FINAL DRAINAGE REPORT
for
MAYBERRY, COLORADO SPRINGS – FILING NO. 3

May 17, 2022

JPS Project No. 030502
EPC Project No. SF-22-___

HORZ. SCALE: 1"=400'
VERT. SCALE: N/A
SURVEYED: N/A
CREATED: 12/03/00
PROJECT NO: 090001
SHEET: EX2

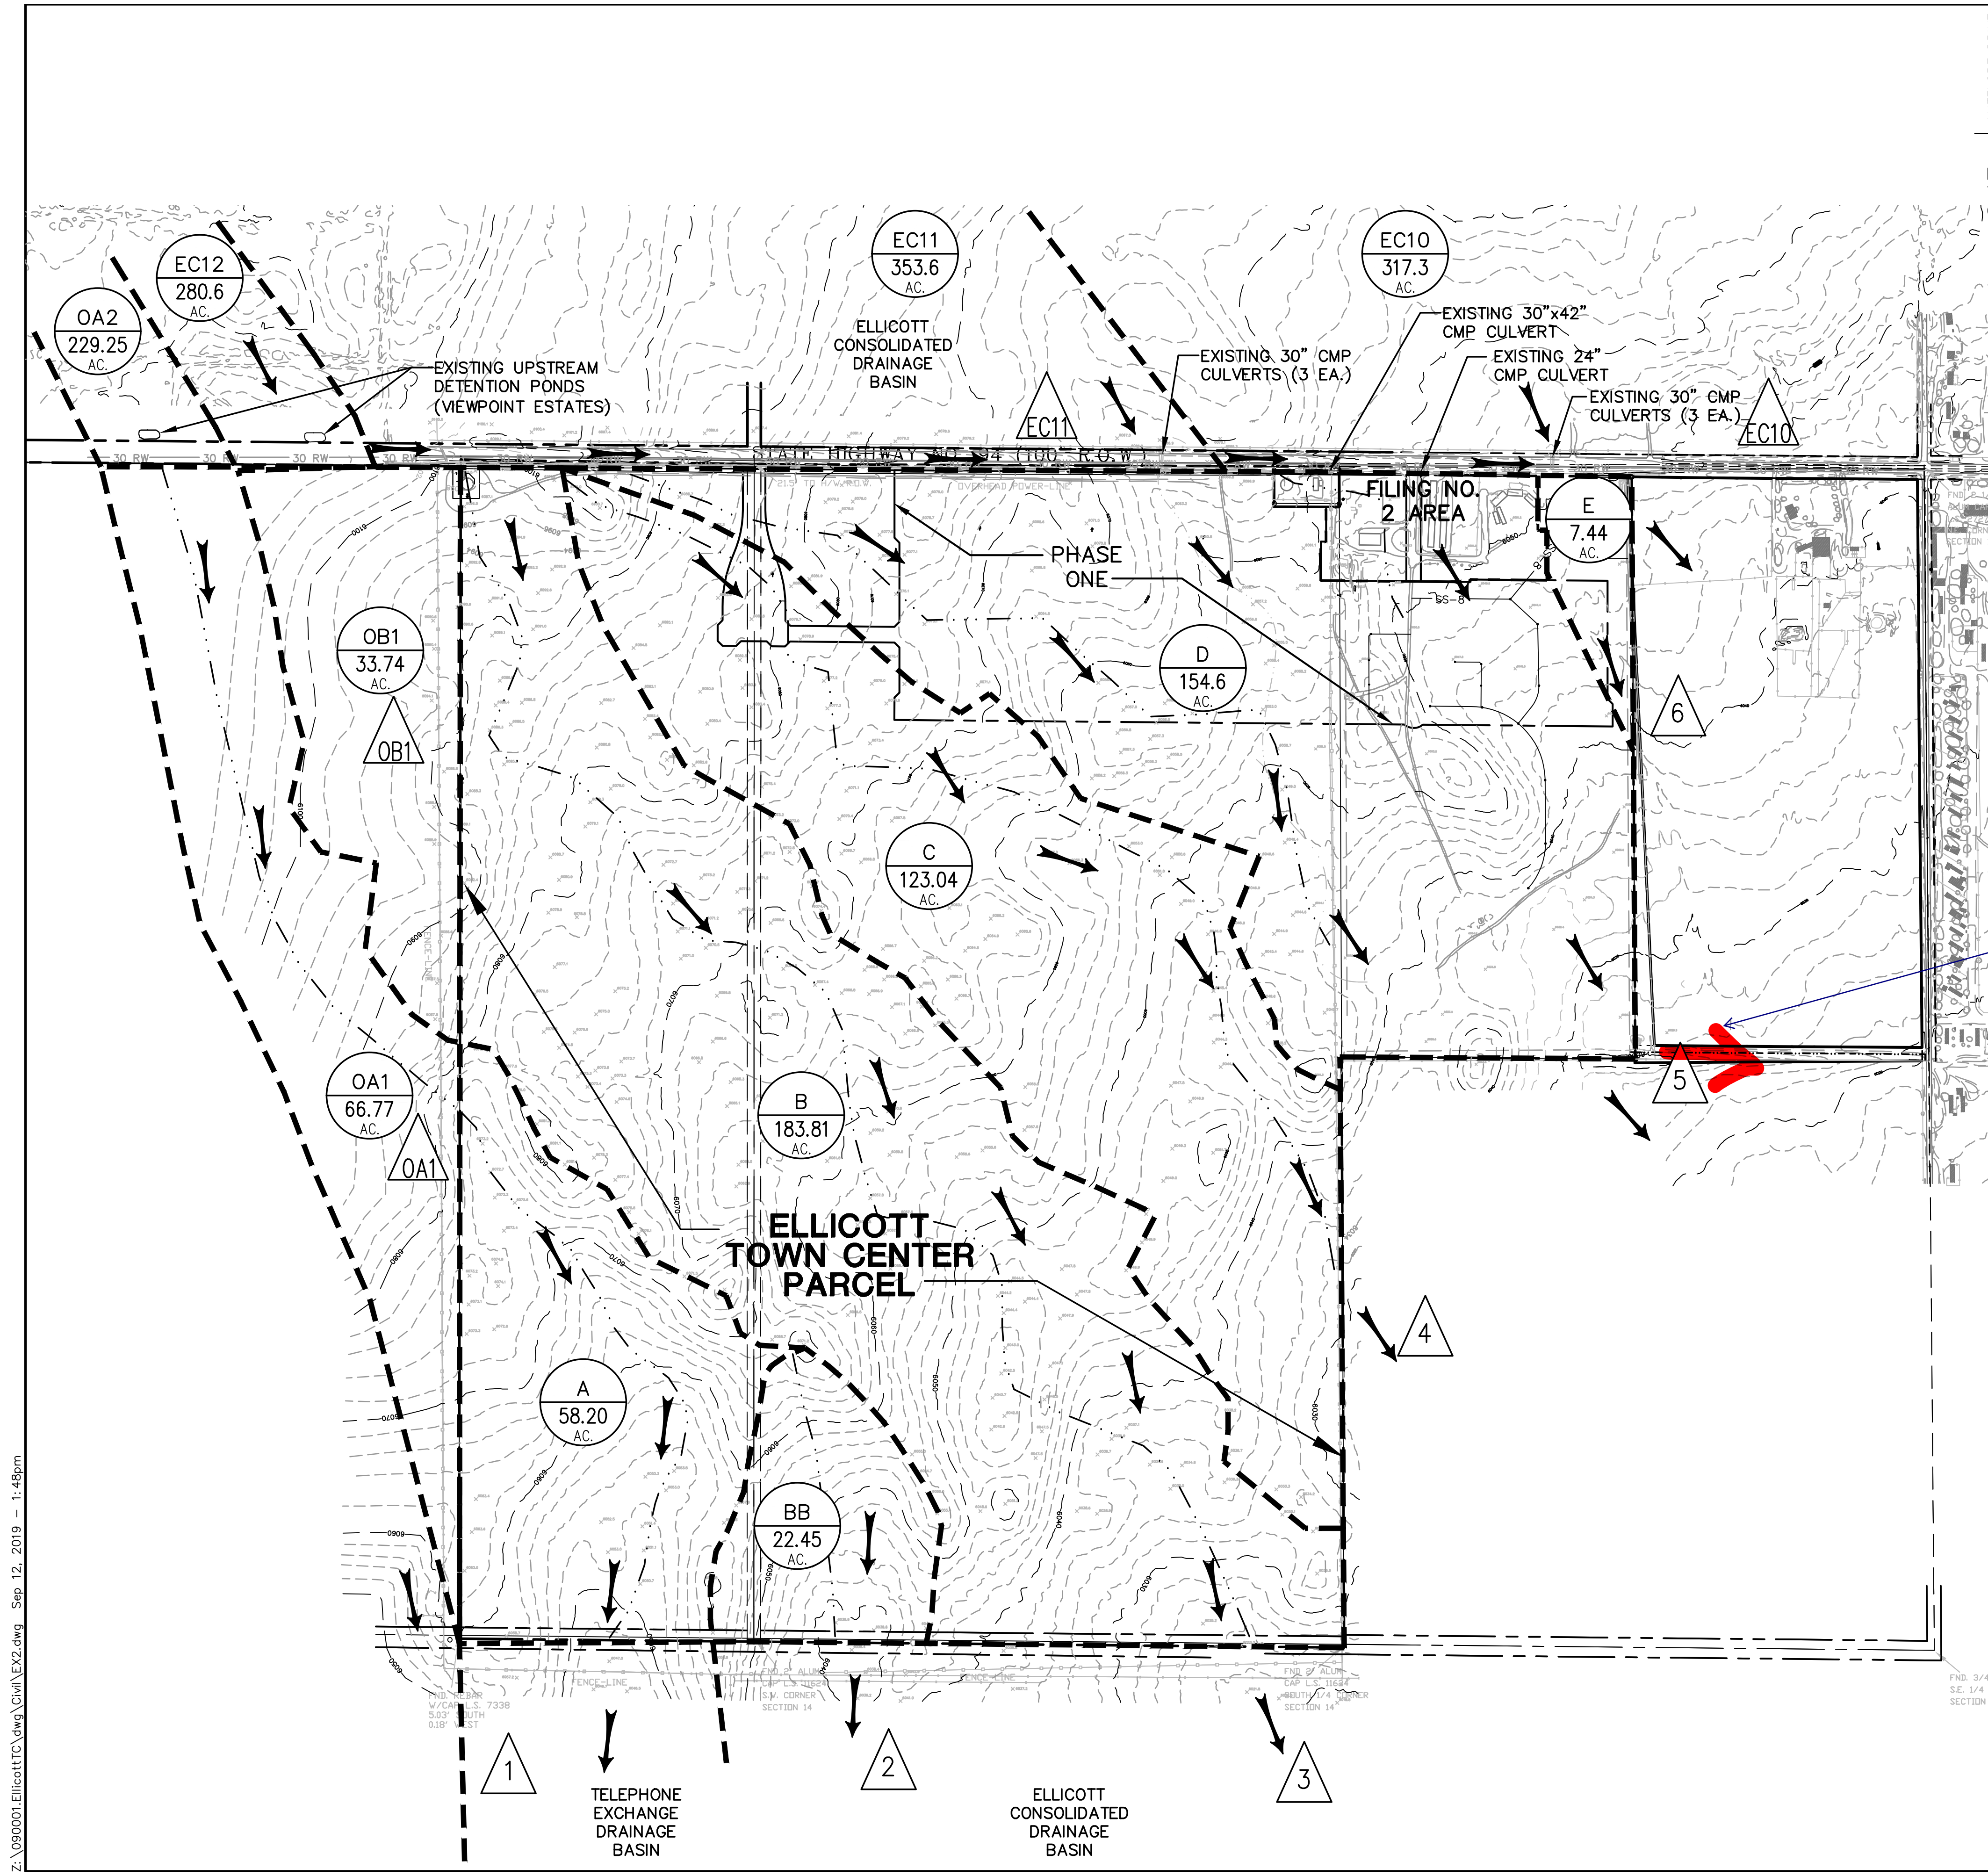
Please clarify/elaborate regarding the outfall of Basin D. Per the existing drainage map the flow turns east into the Gillespie parcel at the southeast corner of the site due to a berm at this location. A comment has been provided on the drainage map to show the appropriate flow arrow on the map.

- FILING LIMITS
- - - DRAINAGE BASIN BOUNDARY
- · - · - FLOWLINE
- 6520 — EXISTING CONTOUR
- ← PROPOSED FLOW DIRECTION ARROW
- △ 5 — DESIGN POINT
- A — BASIN please provide a flow arrow depicting the flow going to the east as there appears to be a berm at this location
- A — BASIN AREA (ACRES)

MASTER DEVELOPMENT DRAINAGE PLAN

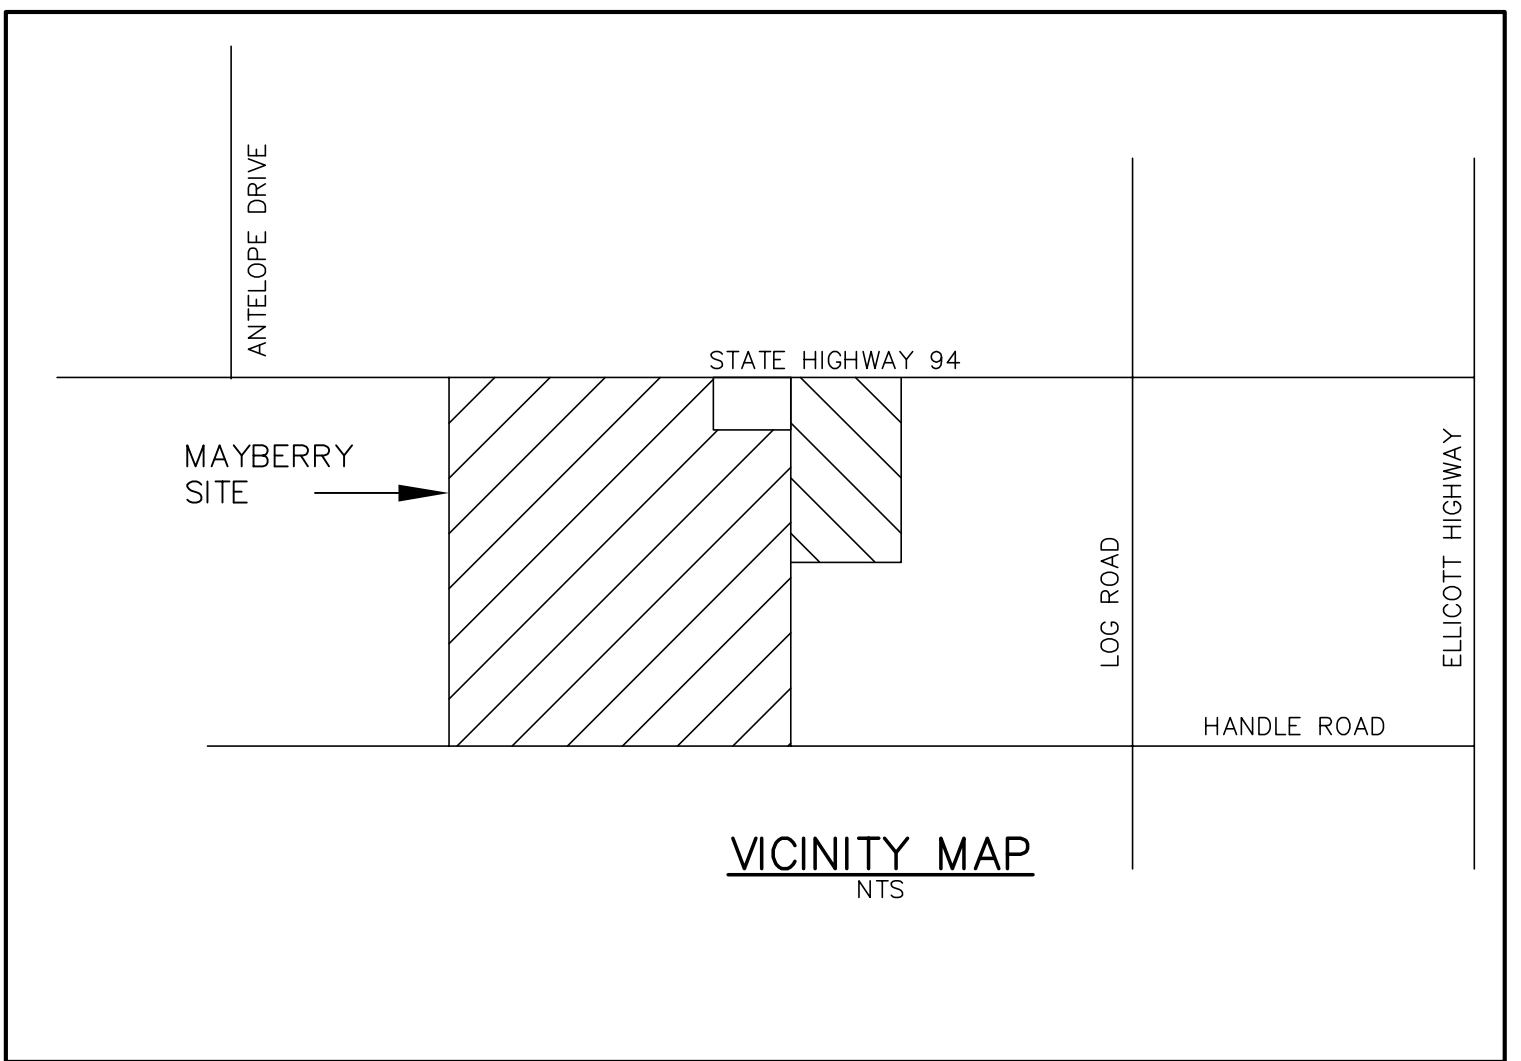
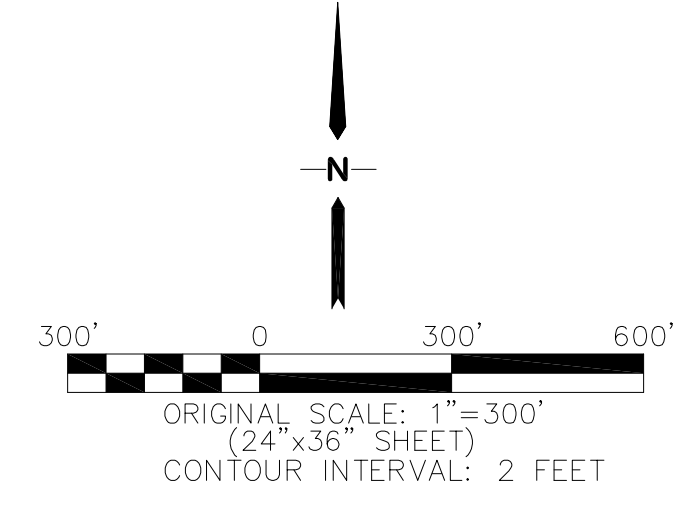
please analyze the existing swale that will convey this total flow to the roadside ditch.

SHEET: **D1.1**

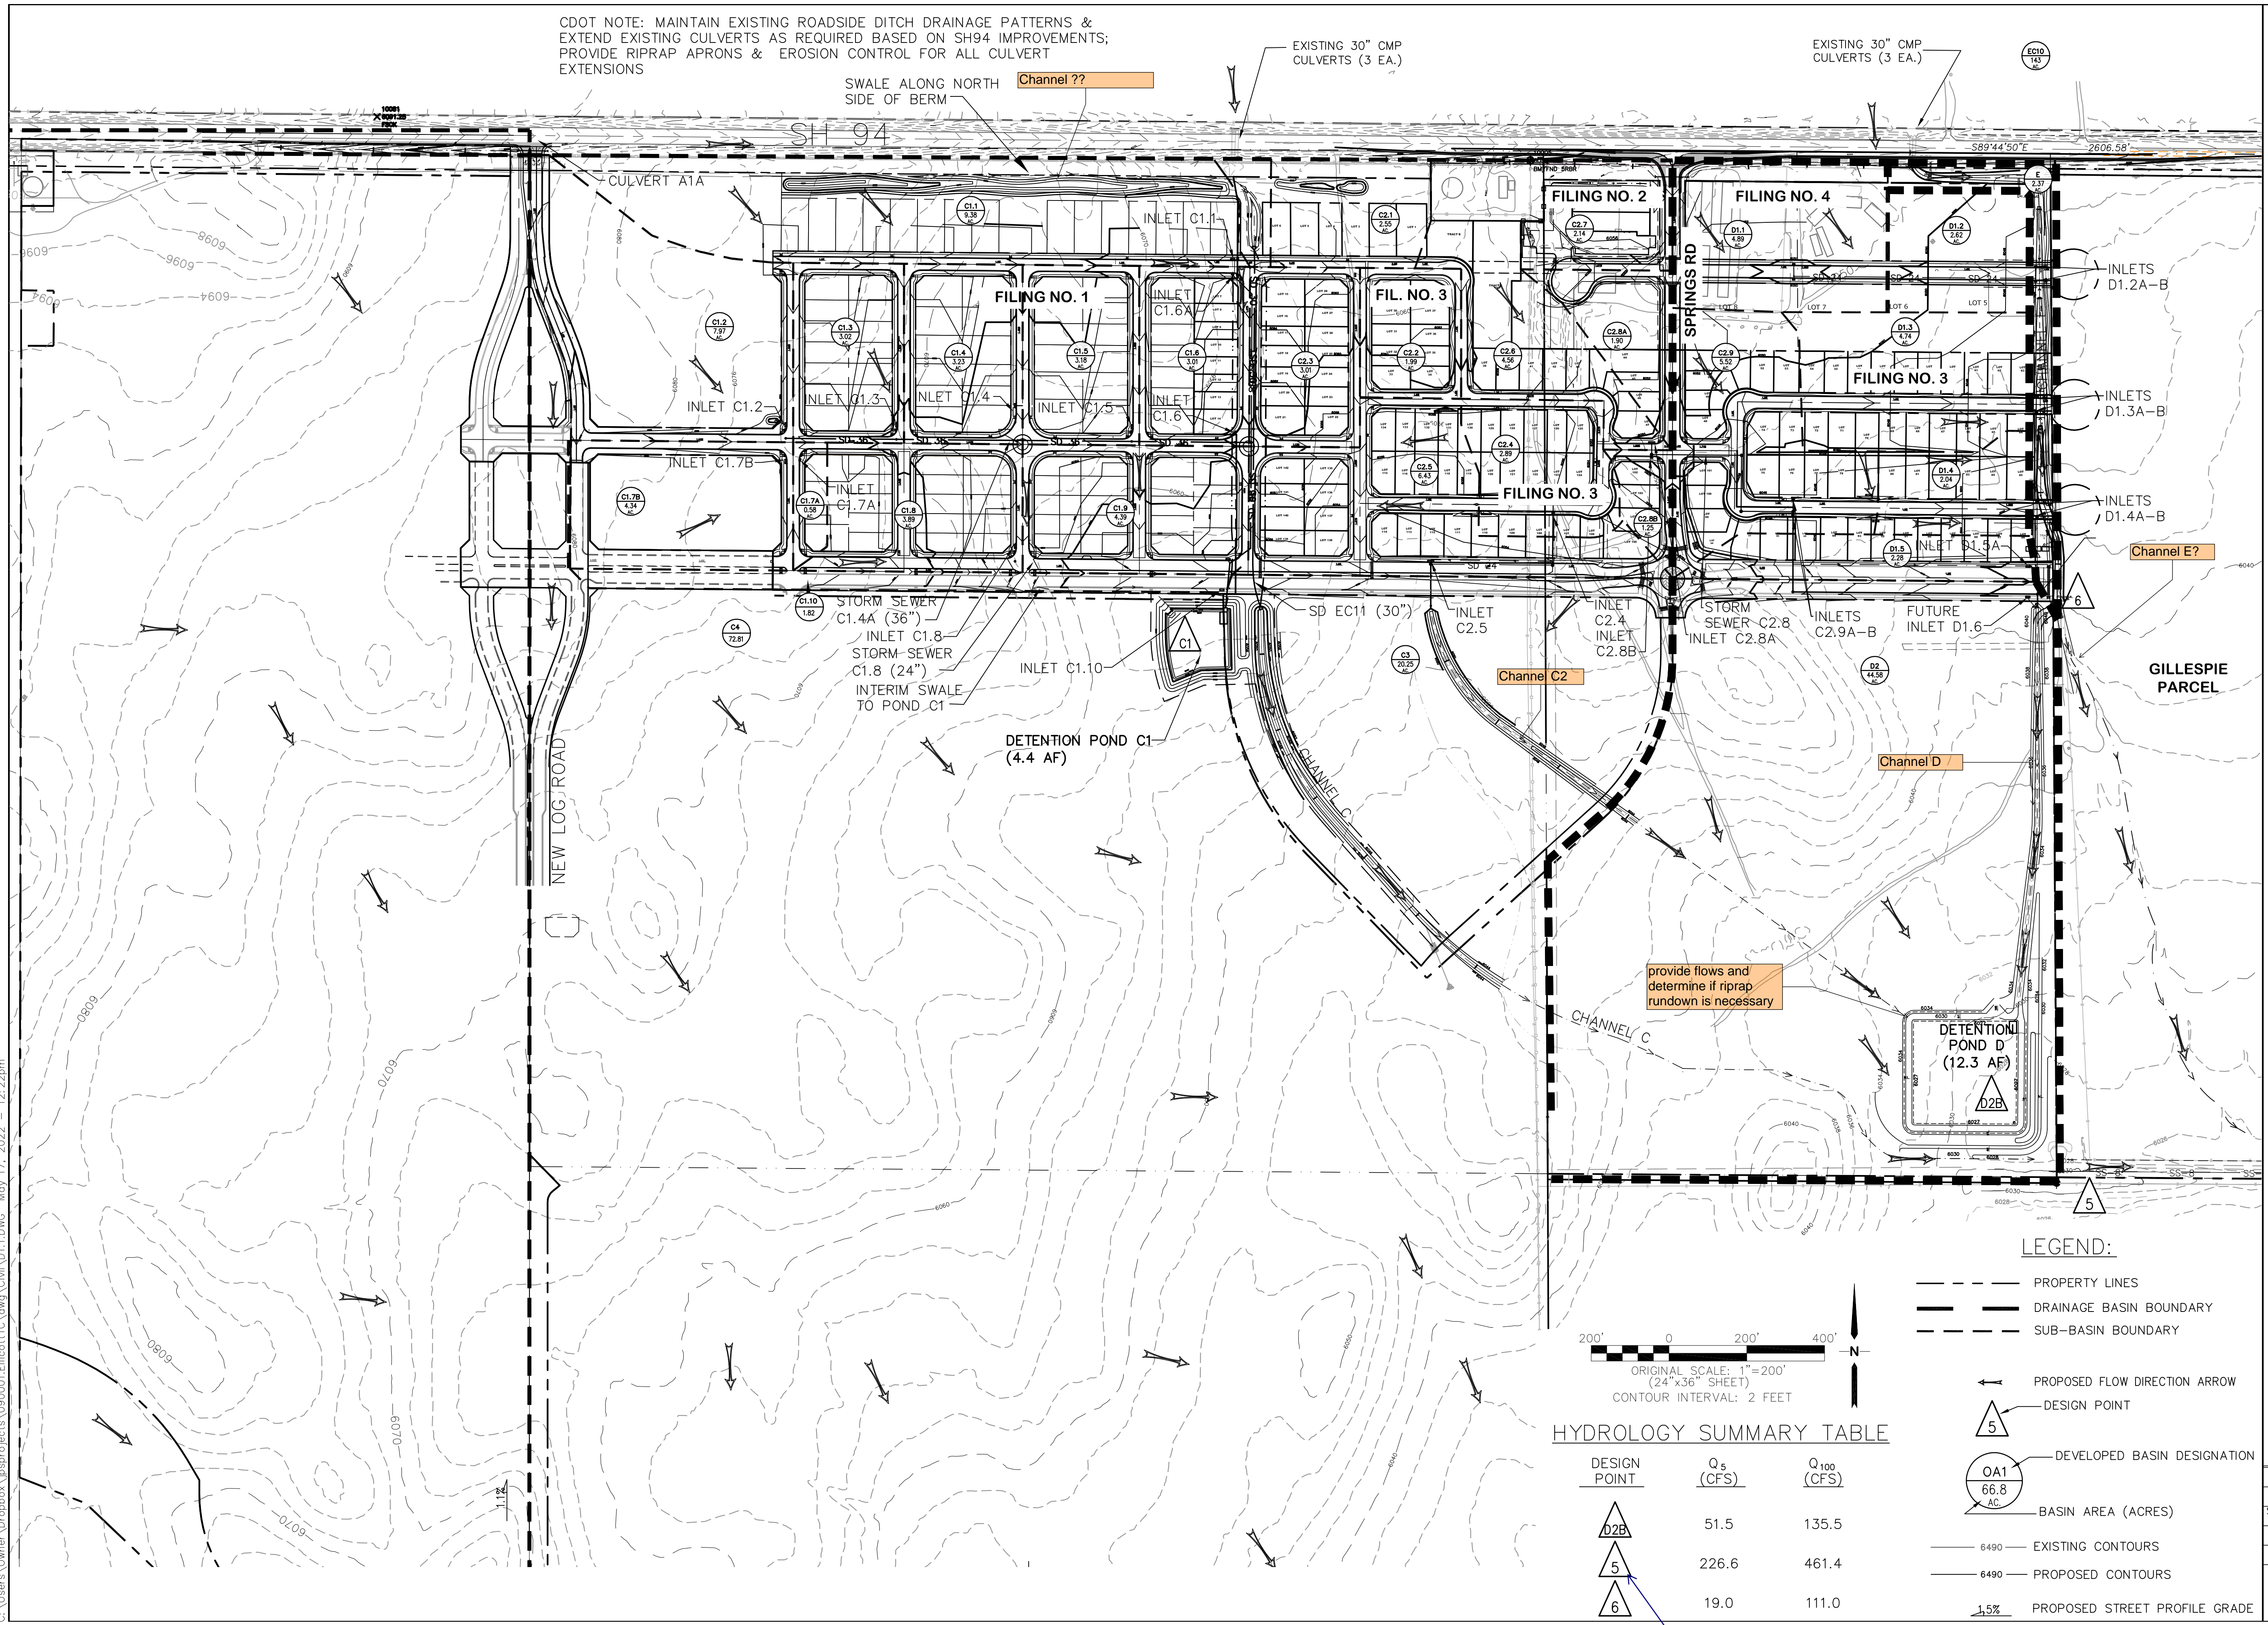
provide flows and determine if riprap rundown is necessary

Please identify that this is the undetained flow and/or also provide the detained total flow at DP5 leaving the site.
